WORCESTER COUNTY PLANNING COMMISSION AGENDA

Thursday, November 5, 2026

III. Waiver Request – 611 Holdings II Storage Yard

IV. Major Site Plan Review – Bayside Jet Drive

COVER SHEET

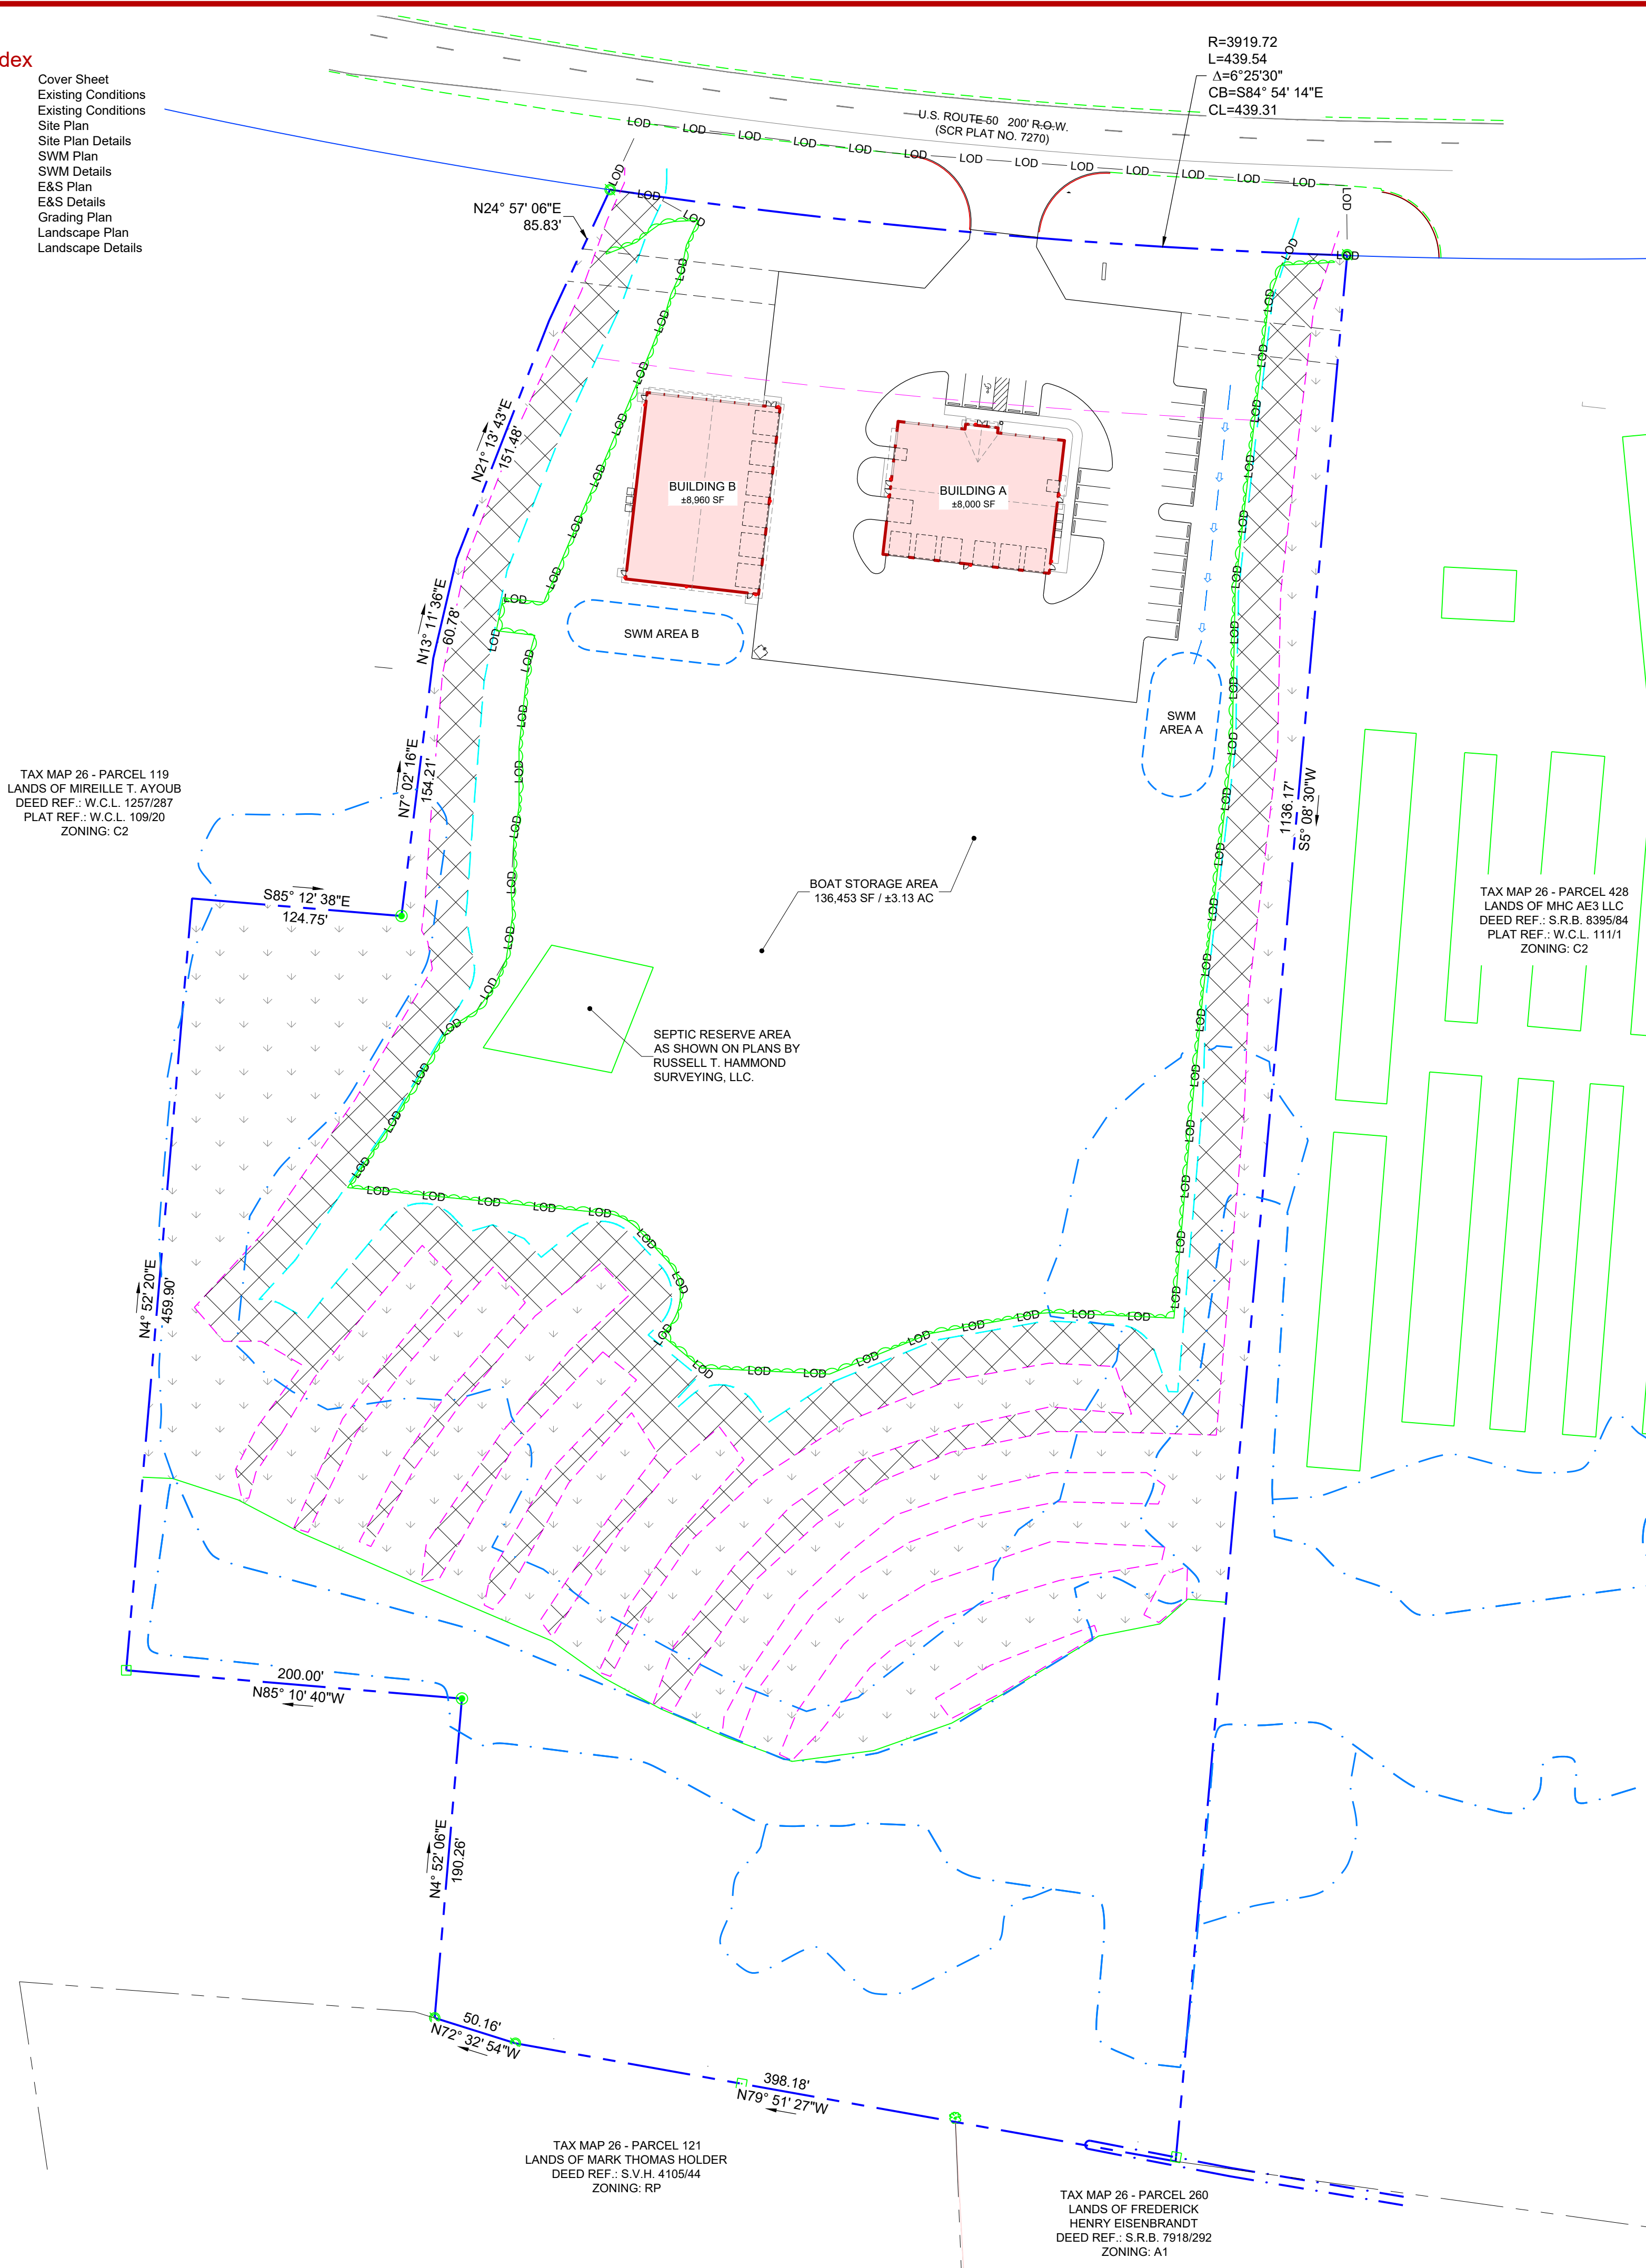
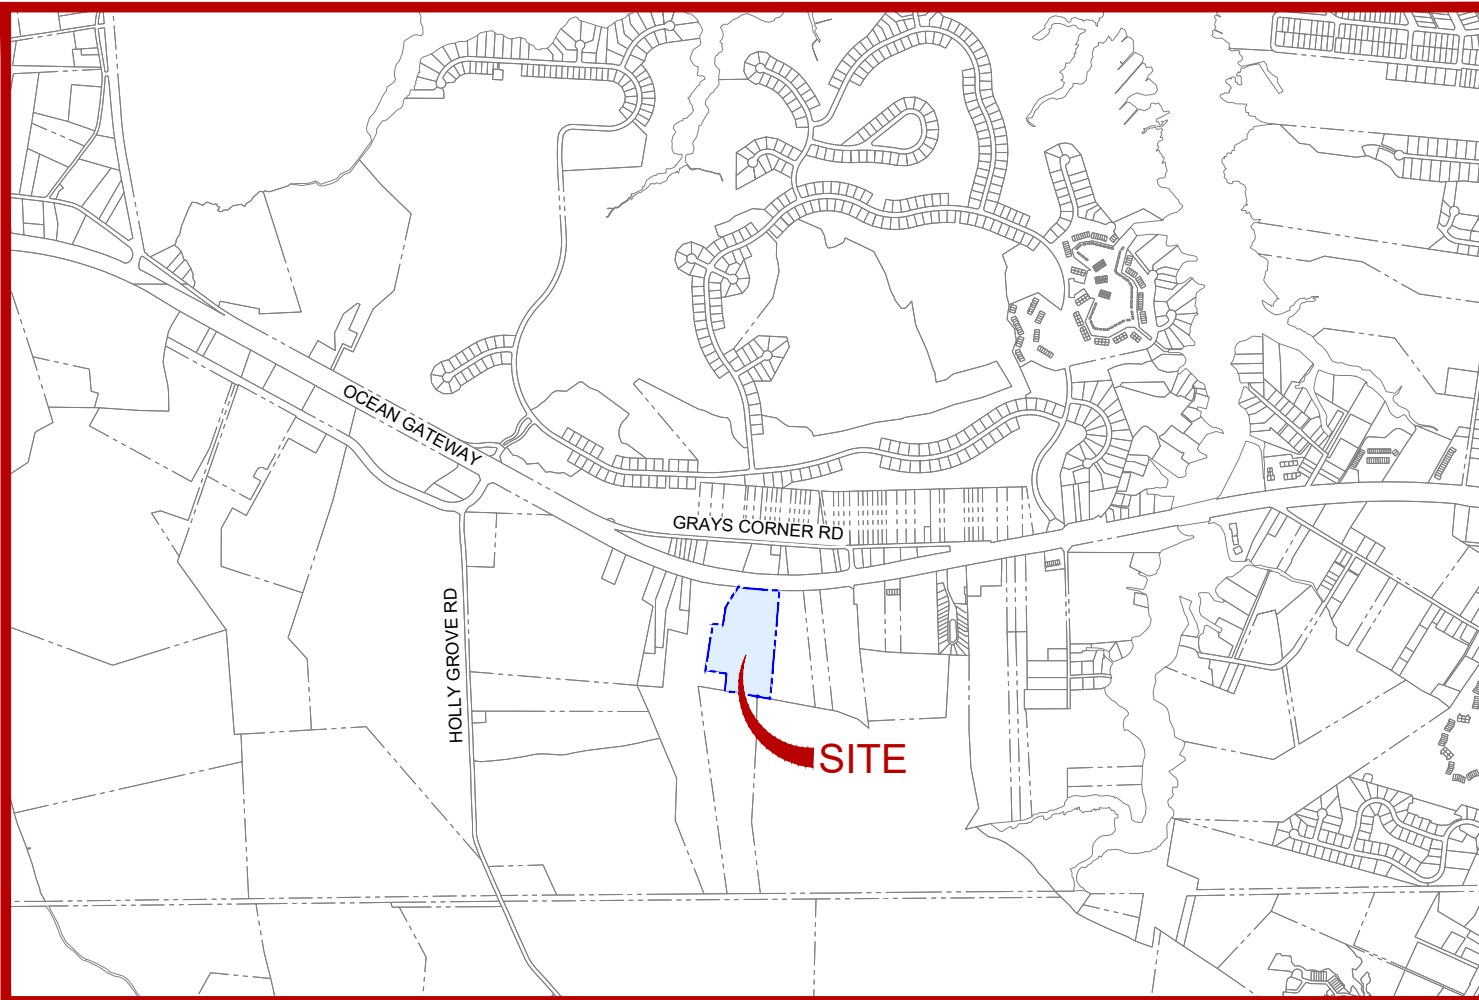
1. The site is limited to 300 Gallons Per Day for onsite sewage disposal. According to the flow chart on Sheet No. G001 of the site plan, the estimated septic usage will not exceed 280 Gallons Per Day. Building B is slated for dry storage only with no use activities or utilities supplied to the structure.
Noted. There have not been changes to the flow chart on Sheet G 001.

SITE PLAN

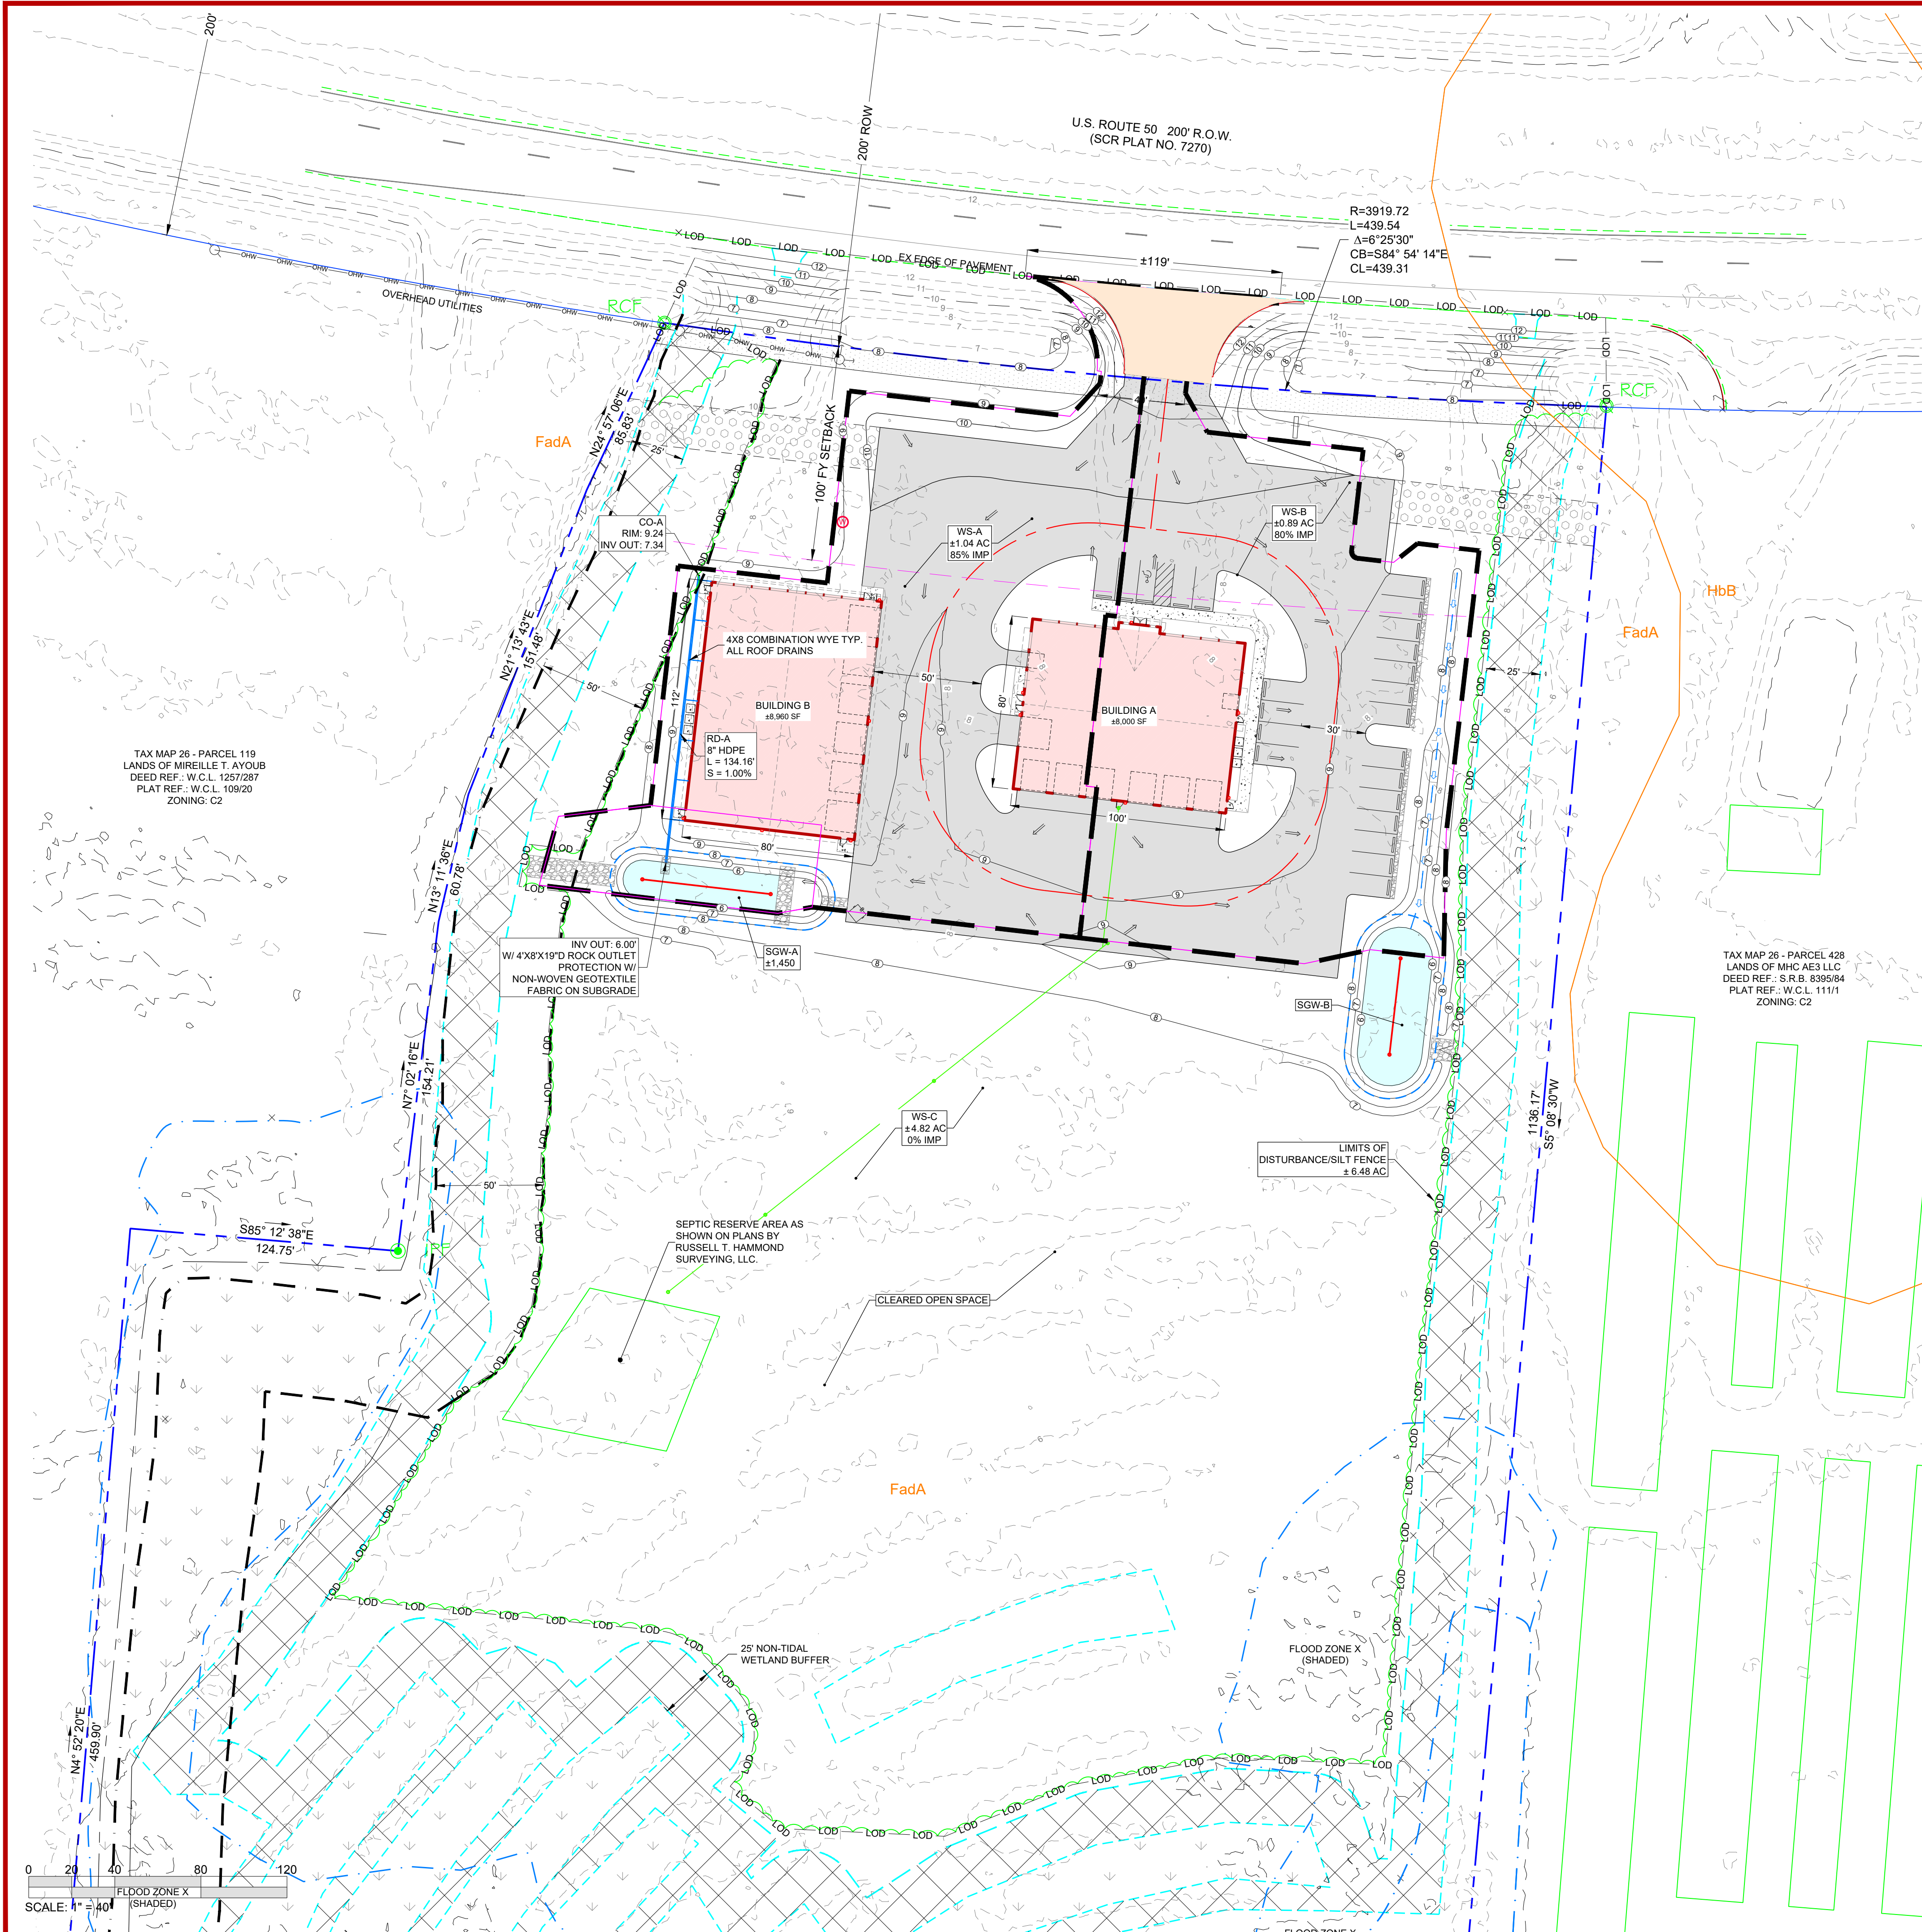
1. Please include at least one litter receptacle at the customer entrance of the retail building and include the location in the plans. §ZS1-320(f)(6).
A litter receptacle has been shown and labeled near the entrance to Building A. Please refer to sheet C 200.

3. Sheet C-200: Please indicate that the edges of the parking and driving areas will be curbed or buffered. §ZS1-320(f)(9).
Wheel stops, as shown on detail 2/C201, are shown at the head of all parking spaces to act as the "curb" for vehicles. In addition to the wheel stops, plantings are provided either adjacent to the parking spaces or adjacent to the pedestrian circulation.

Easements are provided to the adjoining parcels to allow for a 20' wide interparcel connector in the future. This area is shown on all sheets but is labeled and dimensioned on Sheet C 200.
